Downtown Carpark Site Development

FTAA-2512-1158

2.0 Technical Specialist Memo - Landscape

Stephen Quin – Principal Landscape Architect, Planning and Resource Consents Dept

Image 1: AUP:OP Figure H8.6.5.1 Harbour Edge Height Control Plane

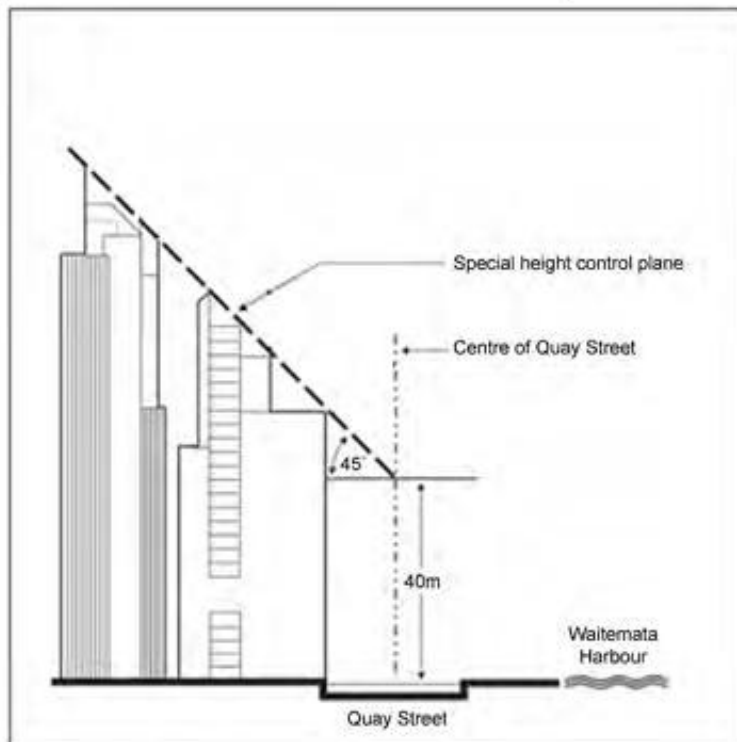
15. The slope of the transition in the control is at 45° , which ensures a gradual stepping back of building height from the waterfront, and this is largely the way in which the city centre is currently formed in relation to the waterfront; reinforced by the recent Commercial Bay development, whilst noting that this recession starts at 60m above the centre of Quay Street³.

16. This gradual 45° transition plane, ensures that tower forms are not overly dominant on the waterfront and that air space is offered above buildings at the point the city centre interacts with Te Waitematā, providing space for this interaction to be experienced, from the waterfront as well as from distant views.

Image 4: AUP:OP Figure H8.6.5.2 Harbour edge height control co-ordinates

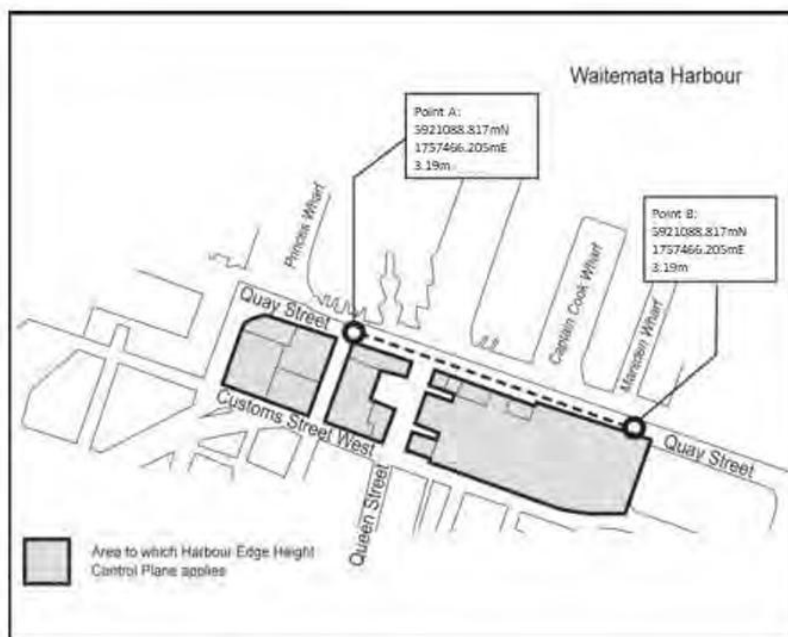
18. The stepping back of height ensures that views from city centre buildings to the Harbour are maximised, equivalent to seating in an amphitheatre ensuring headroom above the observers in the rows closer to the stage – where a very tall person sitting in the front rows of a theatre could cause the view of the stage to be lost for those sitting behind.

19. This requirement for stepping back of building form also has the effect of avoiding a wall of towers facing the Harbour. By staggering height back from the waterfront, this ensures that a depth of city centre form and architecture is enabled through the greater visual permeability into the city centre as approaching from the Harbour. The city centre form is not just the expression of architecture at the front, but of all that can be seen. A collection of buildings and tower forms provide visual interest and helps shape a city's identity.
